February 27, 2025

This letter amends the scope of the proposed work to reflect the changes requested by Council after the first meeting to consider the report as presented on September 3rd, 2024.

Oil Mill Creek Municipal Drain Report

Revision and Version Tracking

Figure 10 Centennial Park Proposed Wetland

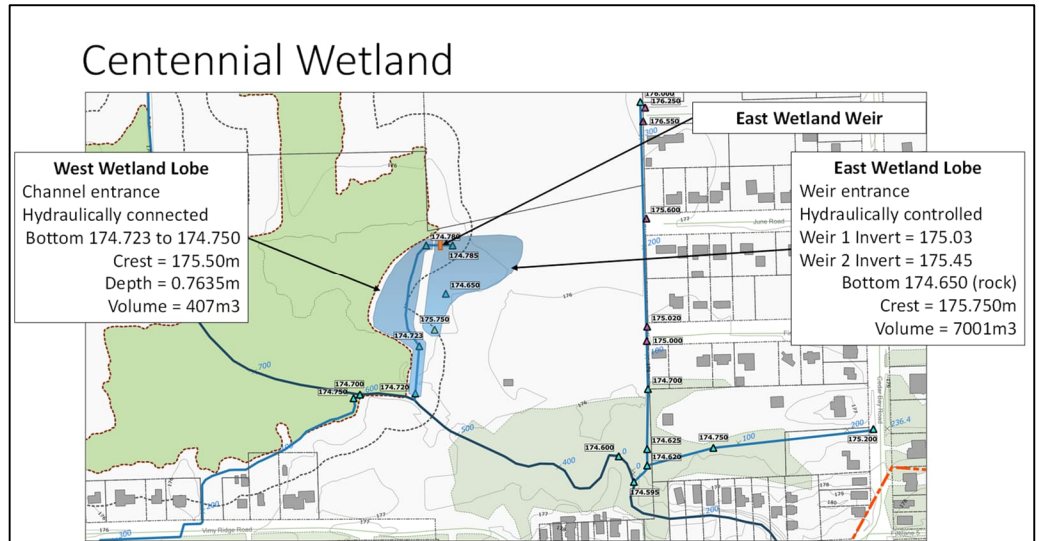
The proposed works for the Centennial Park wetland; drawings, specifications and costs are removed from the Report's proposed scope of work. The descriptions within the Report remain as the City seeks an alternative finance method for the wetland. The amended proposed works do not include any works associated with the constructed runoff storage feature. All other proposed works identified in the Report remain with no other modifications or changes.

The 3 wetland drawings in the original Oil Mill Creek Drain Report, v101 dated June 20, 2024 are removed from this report, which is now identified as version 102 and dated February 27, 2025. This reduces the cost of the proposed works by \$124,515., the estimated cost of constructing the wetland. All other estimated construction costs have remained the same.
